# Access Compliance Report

## Public Rights-of-Way

Intersection ID: 32081	Main Street: KEEGAN_WY	Cross Street: RETANA_DR	Location: NW
ADA ID: 1CC43273889C	Ramp Type: PerpDiag	Initial Pass/Fail: Fail	Overall Compliance: No
		Severity Score: 8.75

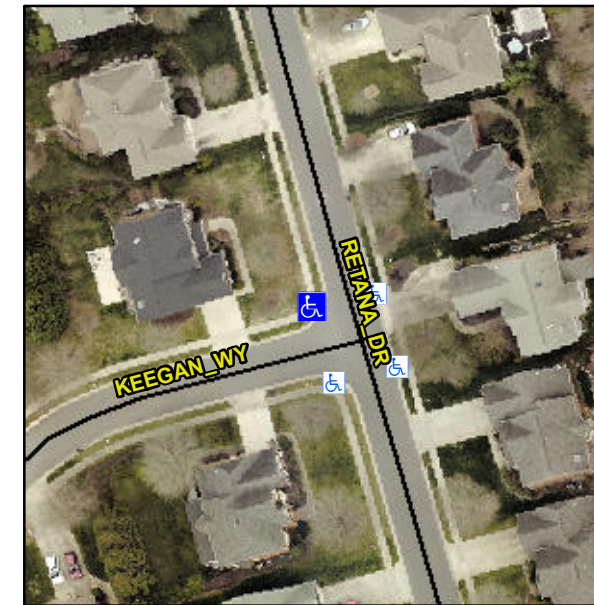
**Not Found, R304.5.1**

Compliance	Description	Data	Compliance	Description	Data
N/A	Ramp Length (in)	49.0	Yes	Ramp Slope (%)	6.7
No	Ramp Width (in)	47.0	Yes	Ramp XSlope (%)	1.9
N/A	Flare Type LT	N/A	N/A	Flare Type RT	N/A
N/A	Flare Slope LT (%)	N/A	N/A	Flare Slope RT (%)	N/A
N/A	Flare Traversable LT?	N/A	N/A	Flare Traversable RT?	N/A
N/A	Landing Length (in)	N/A	N/A	DWS Provided?	N/A
N/A	Landing Width (in)	N/A	N/A	DWS Contrast?	N/A
N/A	Landing Slope (%)	N/A	N/A	DWS Length (in)	N/A
N/A	Landing X Slope (%)	N/A	N/A	DWS Full Width?	N/A
N/A	Landing Curb? (Y/N)	N/A	N/A	DWS Offset (in)	N/A
N/A	Shared Landing?	N/A			
N/A	Gutter Ponding?	N/A	N/A	Gutter Slope (%)	N/A
N/A	Gutter Lip Ht (in)	N/A	N/A	Gutter X Slope (%)	N/A
N/A	Painted X Walk1?	No	N/A	Painted X Walk2?	No
	X Walk 1 Direction	To S		X Walk 2 Direction	To E
N/A	X Walk 1 Width (in)	N/A	N/A	X Walk 2 Width (in)	N/A
	X Walk 1 Slope (%)	3.8		X Walk 2 Slope (%)	5.4
	X Walk 1 X Slope (%)	3.5		X Walk 2 X Slope (%)	2.2

**Remove & Replace Curb Ramp With Two New Directional Ramps or Equivalent.**
